# Economic and Social Council

Item 4.9.12 of the provisional agenda

## **Proposal for Supplement 16 to the 02 series of amendments to UN Regulation No. 117 (Tyre rolling resistance, rolling noise and wet grip)**

### **Submitted by the Working Party on Noise and Tyres\***

Figure 1  
Nomenclature explanation related to grip index of the tyre

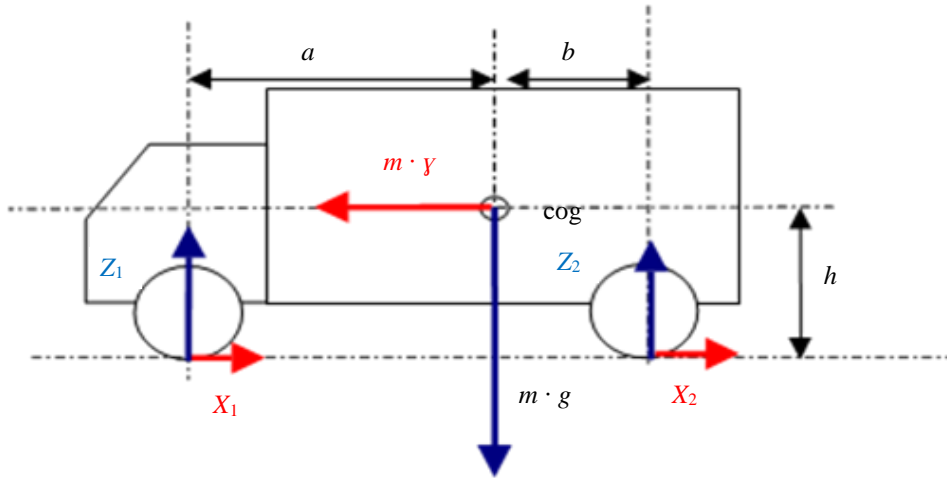
"2.2.2.7.5. Calculation of the relative wet grip index of the tyre

The wet grip index represents the relative performance of the candidate tyre compared to the reference tyre. The way to obtain it depends on the test configuration as defined in paragraph 2.2.2.2. of this Annex. The wet grip index  $G$  of the tyre is calculated as reported into Table 7:

Configuration C1: candidate tyres on both axles	$G = f \cdot \frac{BFC(T)}{BFC(R)}$
Configuration C2: candidate tyres on front axle and reference tyres on rear axle	$G = f \cdot \frac{BFC(T) \cdot [a + b + h \cdot BFC(R)] - a \cdot BFC(R)}{BFC(R) \cdot [b + h \cdot BFC(T)]}$
Configuration C3: reference tyres on front axle and candidate tyres on rear axle	$G = f \cdot \frac{BFC(T) \cdot [-a - b + h \cdot BFC(R)] + b \cdot BFC(R)}{BFC(R) \cdot [-a + h \cdot BFC(T)]}$

<i>For class C2 tyres</i>	
<i>SRTT16C</i>	
<i>f = 1</i>	
<i>For class C3 tyres</i>	
<i>SRTT19.5, SRTT22.5</i>	<i>SRTT19.5 siped, SRTT22.5 siped</i>
<i>f = 1</i>	<i>f = 1.02</i>

Where (see also Figure 1):

- f*: correction factor depending on used SRTT
  - cog*: centre of gravity of the loaded vehicle
  - m*: mass (in kilograms) of the loaded vehicle
  - a*: horizontal distance between front axle and centre of gravity of the loaded vehicle (m)

- b*: horizontal distance between rear axle and centre of gravity of the loaded vehicle
  - h*: vertical distance between ground level and centre of gravity of the loaded vehicle (m).

- N.B.* When *h* is not precisely known, these worst case values shall apply: 1.2 for configuration C2, and 1.5 for configuration C3
- γ*: loaded vehicle acceleration [m·s<sup>-2</sup>]

- g*: acceleration due to the gravity [m·s<sup>-2</sup>]
  - X*<sub>1</sub>: longitudinal (X-direction) reaction of the front tyre on the road
  - X*<sub>2</sub>: longitudinal (X-direction) reaction of the rear tyre on the road

- Z*<sub>1</sub>: normal (Z-direction) reaction of the front tyre on the road
  - Z*<sub>2</sub>: normal (Z-direction) reaction of the rear tyre on the road

Figure 1

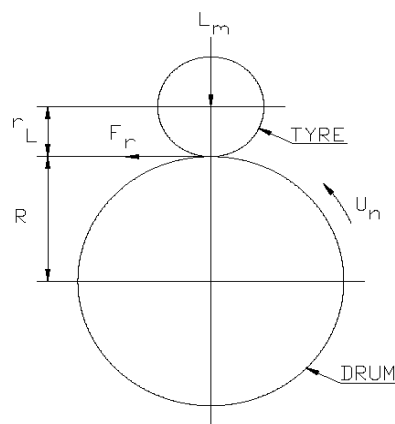
"4.5. Measurement and recording

The following shall be measured and recorded (see Figure 1):

- (a) Test speed  $U_n$ ;
- (b) Load on the tyre normal to the drum surface  $L_m$ ;
- (c) The initial test inflation pressure as defined in paragraph 3.3. above;
- (d) The coefficient of rolling resistance measured  $C_r$ , and its corrected value  $C_{rc}$ , at 25 °C and for a drum diameter of 2 m;
- (e) The distance from the tyre axis to the drum outer surface under steady state  $r_L$ ;
- (f) Ambient temperature  $t_{amb}$ ;
- (g) Test drum radius  $R$ ;
- (h) Test method chosen;
- (i) Test rim (size and material);
- (j) Tyre size, manufacturer, type, identity number (if one exists), speed category symbol, load index, DOT number (Department of Transportation).

All the mechanical quantities (forces, torques) will be orientated in accordance with the axis systems specified in ISO 8855:2011.

The directional tyres shall be run in their specified rotation sense."
